FINAL TECHNICAL REPORT NO.9

PHASE 2 STAGE 2C
SELECTION OF PREFERRED SITE

NOISE ASSESSMENT

ENVIRONMENTAL
ASSESSMENT
LANDFILL COMPONENT OF
SOLID WASTE MANAGEMENT

BARMAN COULTER SWALLOW ASSOCIATES			Suite 401, 1 Greensboro Drive, Rexdale, Ontario M9W 1C8 Telephone (416) 245-7501		TITLE SOUND MITIGATION BERM SECTION	
			ENG JEC		PROJECT HALTON LANDFILL	
			DRW JEC		CLIENT HALTON	
			CHK		DATE 84/12/04	
					FIGURE: 1

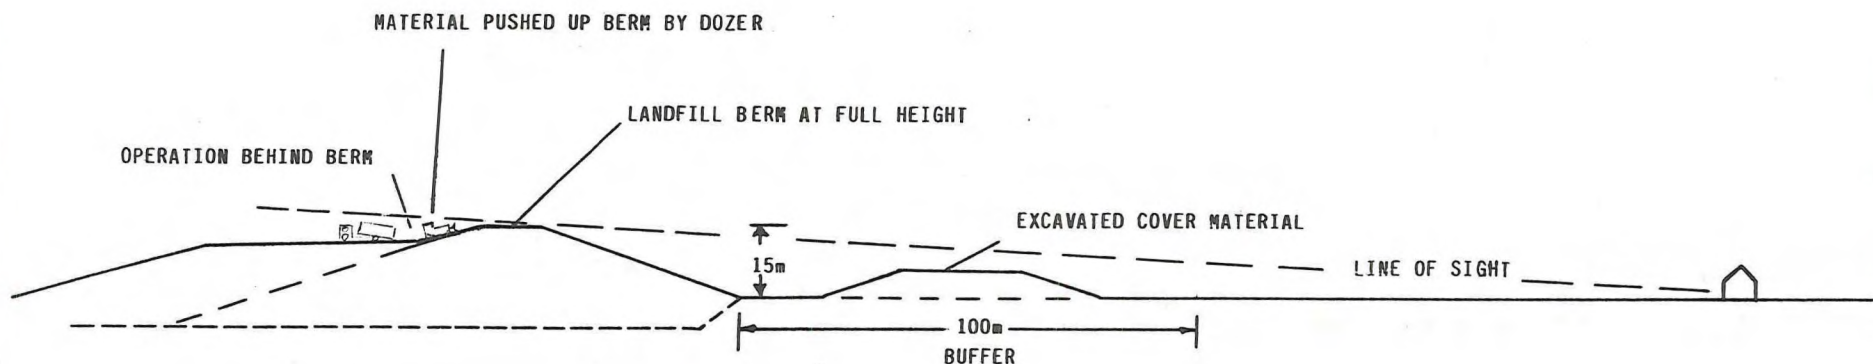
quite high
how high is
that?!

400m -
berm in
a year

MAP 4

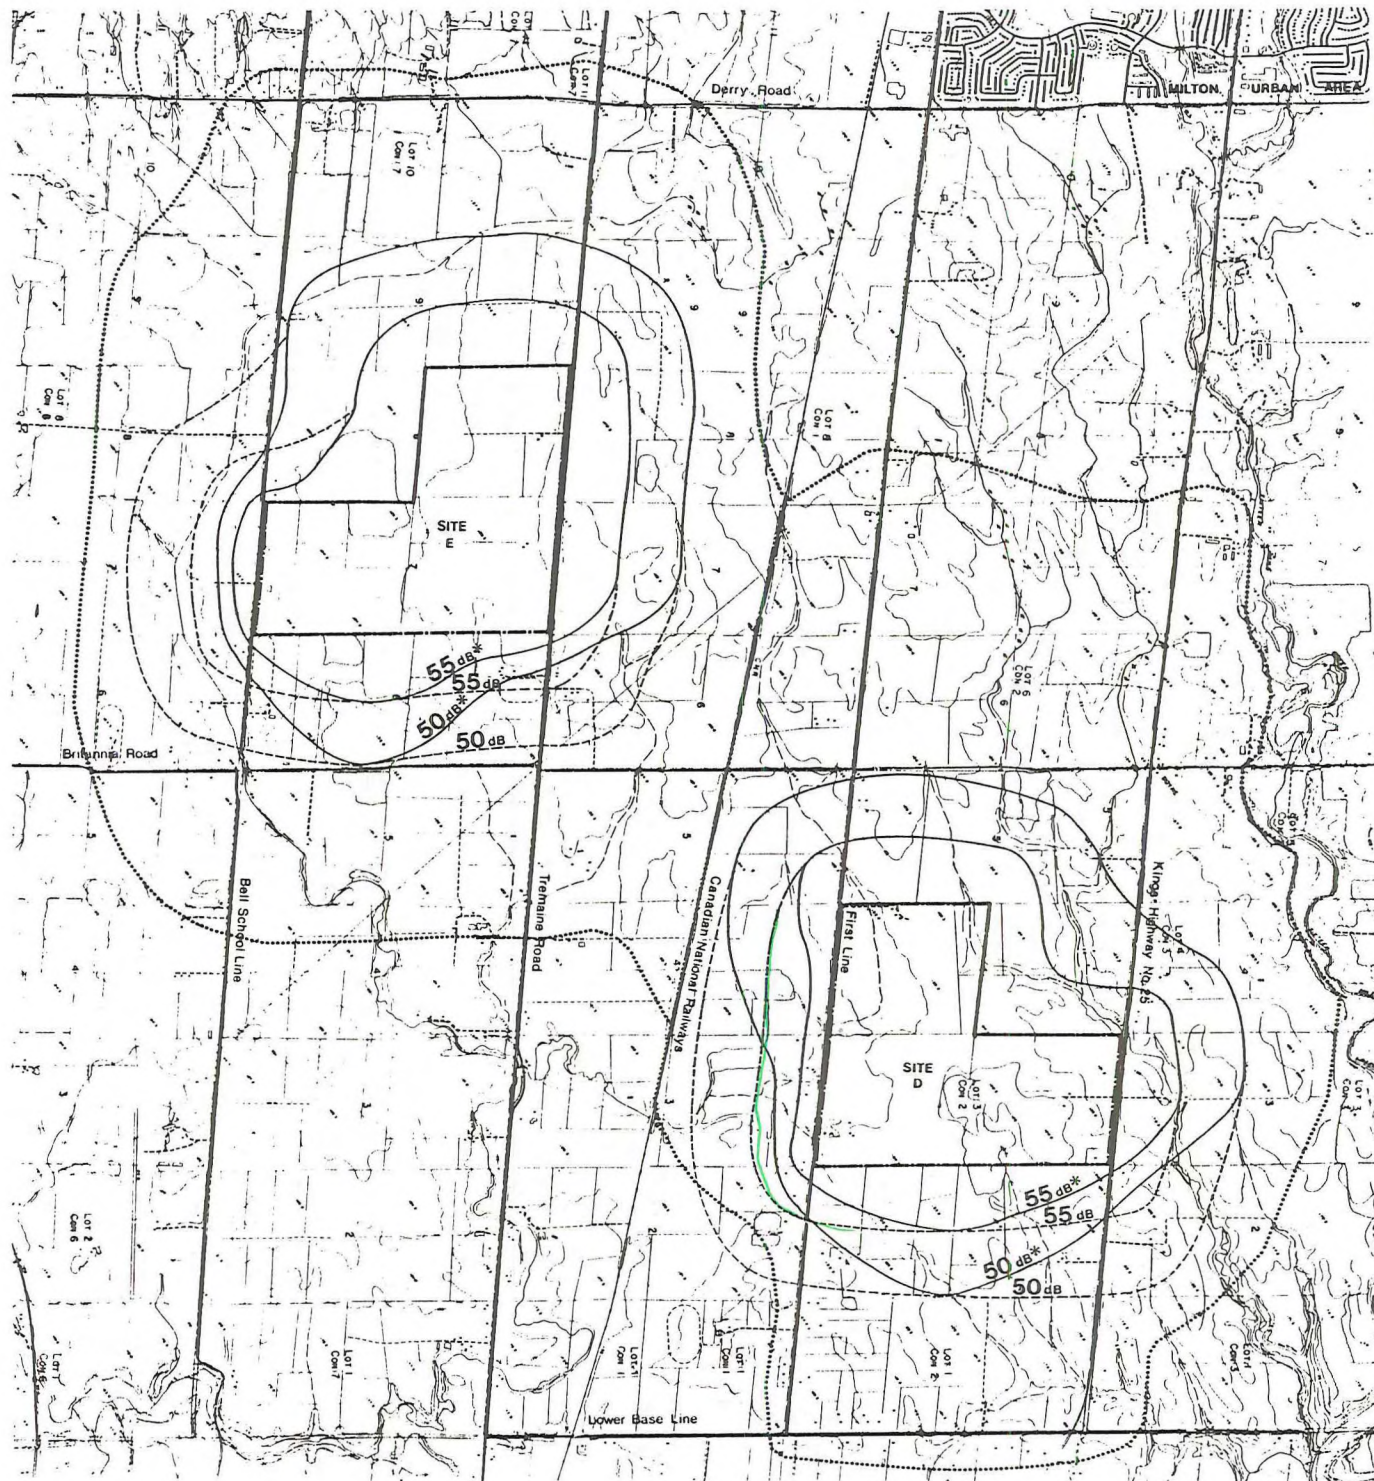
sub traffic
now at D
that road
truck noise
will not
exceed
not crit.
even on
hourly
basis!!

10 homes
over MOE
crit for
1 year;
after berm
15 over
50 dB during
day
